S E R V I C E N O T E

HP 5343A Microwave Frequency Counter

**A1 Display Assembly P/N 05342-60004 Revision E
HP-IB LED Indicators May Give Erroneous Indications**

Figure 1. Good Revision E A1 Display Assembly (Back Side)

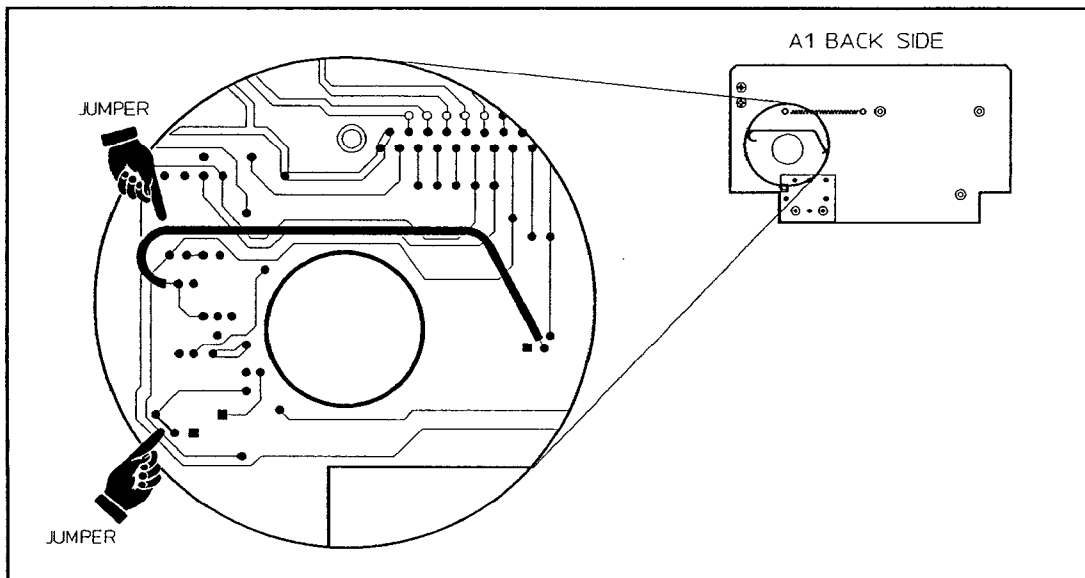
Some Revision E A1 Display Assemblies have been constructed with improperly connected HP-IB LED indicators. These indicators will light after certain combinations of key presses. This problem only affects the front-panel display of the actual state of the instrument. It indicates activity on the HP-IB bus when none is actually present. Excluded serial numbers are 2826A02791, 2826A02793, and 2826A02795

If the A1 Display Assembly has the two jumpers shown in Figure 1, this is the working version of the revision E boards. If the board does NOT have these jumpers, it needs to be repaired.

1. You must solder two jumpers on the back side of the A1. The jumpers are shown on *Figure 1*.
2. You must cut two traces on the front side of the A1. The location of the two cuts are circled on *Figure 2*. The first is to the left of the LISTEN LED, between the cathode of a diode and the words "LISTEN". The second is between the words "TALK" and "REM".
